CHURCH OF THE REDEEMER SUBDIVISION

APPLICATION NUMBER 19 DATE April 17, 2008

DETAIL SITE PLAN

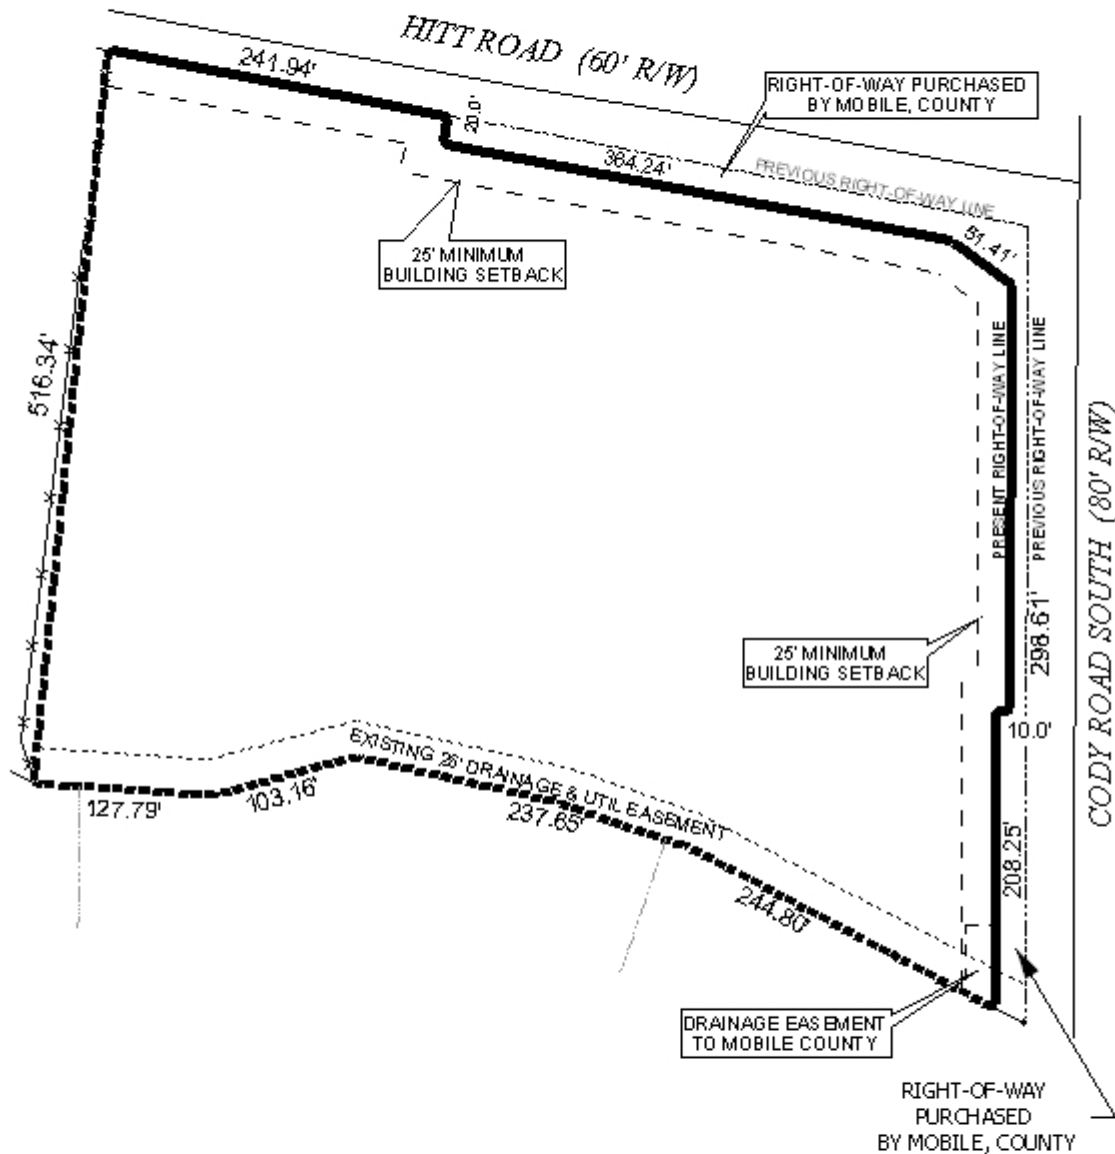
The site fronts Cody Road South and Hitt Road. Cody Road is a proposed major street with a planned 100' right-of-way. The plat indicates a current 80' right-of-way width along the Northern portion of the Cody Road South frontage; however, the plat scales the right-of-way width to be 45' from centerline along this portion of the site. The Southern portion along Cody Road South does not indicate a right-of-way width; however, the width scales to be 55' from the centerline of Cody Road South. The plat should be revised to correct the discrepancies between stated and scaled right-of-way widths along Cody Road South, and the dedication of sufficient right-of-way to provide 50' from the centerline of Cody Road South would be required where insufficient. Hitt Road is indicated to have a 60' right-of-way width along the Western portion of the site, and the plat scales to such, and scales to have a 100' right-of-way width toward the Eastern portion of the site along Hitt Road, though not dimensioned on the plat. Such right-of-way width would be compliant, but the plat should be revised to dimension the width at these two portions along Hitt Road. The plat indicates a 25' minimum building setback line along both street frontages and this should also be illustrated on the final plat, but revised to be measured from any required dedication. As a means of access management, a note should be placed on the final plat limiting the lot to two curb cuts to Cody Road South and two curb cuts to Hitt Road, with the size, location, and design of all curb cuts to be approved by County Engineering and conform to AASHTO standards.

The lot is labeled with its size in acres and square feet and this should also be done on the final plat, or a table should be provided furnishing the same information.

- 1) revision of the plat to correct the discrepancies between the stated and scaled right-of-way widths along Cody Road South;
- 2) dedication of sufficient right-of-way to provide 50' from centerline along Cody Road South;

- 3) revision of the plat to state the right-of-way width of Hitt Road at both the narrow and wider portions;
- 4) illustration of the 25' minimum building setback line along both street frontages as measured from any required right-of-way dedication;

- 5) placement of a note on the final plat stating that the lot is limited to two curb cuts to Cody Road South and two curb cuts to Hitt Road, with the size, location and design of all curb cuts to be approved by County Engineering and conform to AASHTO standards;

- 6) labeling of the lot with its size in square feet and acres, or the provision of a table on the plat furnishing the same information;
- 7) placement of a note on the final plat stating that the development will be designed to comply with the storm water detention and drainage facility requirements of the City of Mobile storm water and flood control ordinances, and requiring submission of certification from a licensed engineer certifying that the design complies with the storm water detention and drainage facility requirements of the City of Mobile storm water and flood control ordinances prior to the issuance of any permits. Certification is to be submitted to the Planning Section of Urban Development and County Engineering;
